Subject: USNRC Docket No. 72-1014, TAC L23344
HI-STORM 100 Certificate of Compliance 1014
HI-STORM License Amendment Request 1014-1, Revision 2, Supplement 3

Pursuant to our communication of October 10, 2001, attached herewith is Supplement 3 to License Amendment Request (LAR) 1014-1, Revision 2. Supplement 3 contains the required information on the Forced Helium Dehydration (FHD) system to be used to reduce the moisture in the MPCs to trace levels, when vacuum drying is not permitted or is otherwise an undesirable method of drying the MPC. Enclosed are the following documents:

INSTRUCTIONS FOR LAR 1014-1, REV. 2, SUPPLEMENT 3

FIGURE 2.B.1: SCHEMATIC OF THE FORCED HELIUM DEHYDRATION SYSTEM

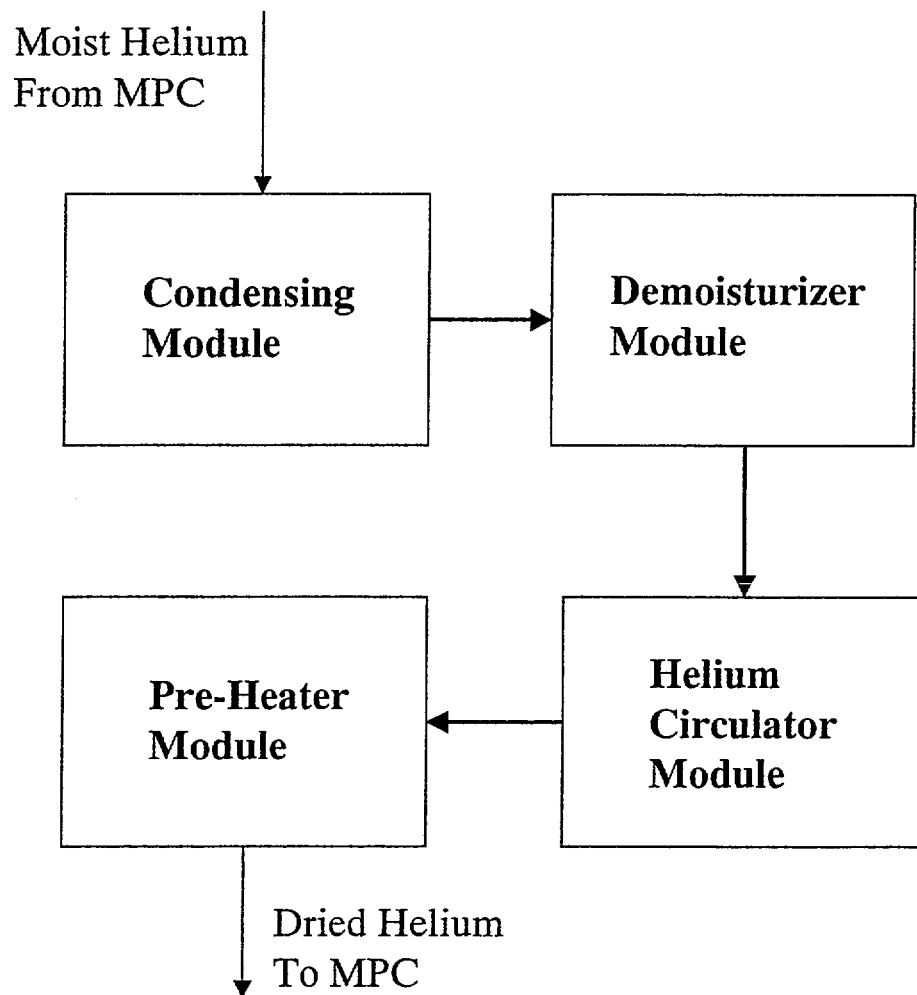
The FHD system, schematically illustrated in Figure 2.B.1, can be viewed as an assemblage of four thermal modules, namely, (i) the condensing module, (ii) the demister module, (iii) the helium circulator module and (iv) the pre-heater module. The condensing module serves to cool the helium/vapor mixture exiting the MPC to a temperature well below its dew point such that water may be extracted from the helium stream. The condensing module is equipped with suitable instrumentation to provide a direct assessment of the extent of condensation that takes place in the module during the operation of the FHD system. The demister module, engineered to receive partially cooled helium exiting the condensing module, progressively chills the recirculating helium gas to a temperature that is well below the temperature corresponding to the partial pressure of water vapor at 3 torr.

The motive energy to circulate helium is provided by the helium circulator module, which is sized to provide the pressure rise necessary to circulate helium at the requisite rate. The last item, labeled the pre-heater module, serves to pre-heat the flowing helium to the desired temperature such that it is sufficiently warm to boil off any water present in the MPC cavity.

The pre-heater module, in essence, serves to add supplemental heat energy to the helium gas (in addition to the heat generated by the stored SNF in the MPC) so as to facilitate rapid conversion of water into vapor form. The heat input from the pre-heater module can be adjusted in the manner of a conventional electric heater so that the recirculating helium entering the MPC is sufficiently dry and hot to evaporate water, but not unduly hot to place unnecessary thermal burden on the condensing module.
